32-BIT MICROCONTROLLER **MB91360 SERIES**

FUNCTIONAL LIMITATION
CAN INTERRUPT SETTING

2009-03-27

5.1 Correct function (e.g. configuration with CLKP:CLKT even divider):

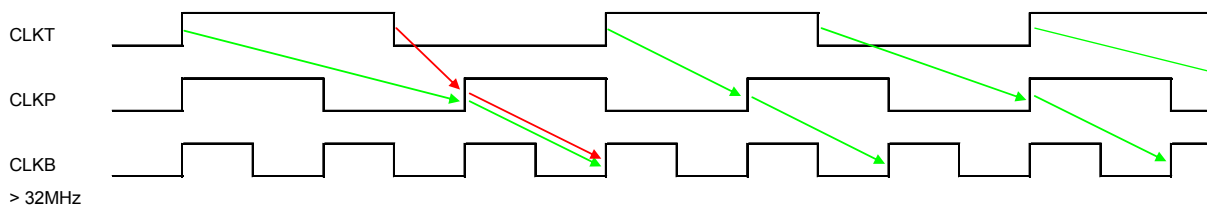
There is no short path for $CLKB \leq 64MHz$ (green arrows).

CLKT is synchronizing CAN interrupts from CAN clock domain (asynchronous to core domain) to core clock domain, interrupts to Interrupt Unit (I-UNIT) are output on both rising edge and falling edge CLKT (due to IRQ latency performance). CLKP is capturing the interrupt signal within Interrupt Unit (I-UNIT) and providing Vector/Level to CPU (CLKB domain).

6.3 Workaround function (e.g. configuration with CLKP:CLKT odd divider):

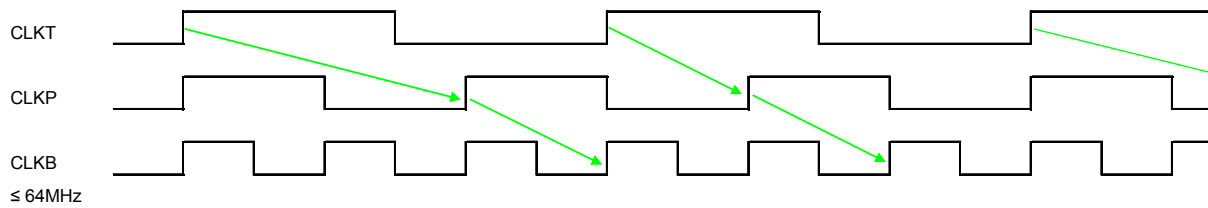
There is no short path for $CLKB \leq 64MHz$.

Interrupts are only output with rising edge CLKT to Interrupt Unit (CLKP domain) - a short path between CLKT and CLKP is prevented.

Drawback of the proposed workaround is the slightly higher interrupt latency. But it is judged as negligible for small division ratios of CLKP and CLKT. In above's example with $CLKB:CLKP:CLKT = 1:2:3$ there are only a maximum of 2 additional core clocks (CLKB) necessary.
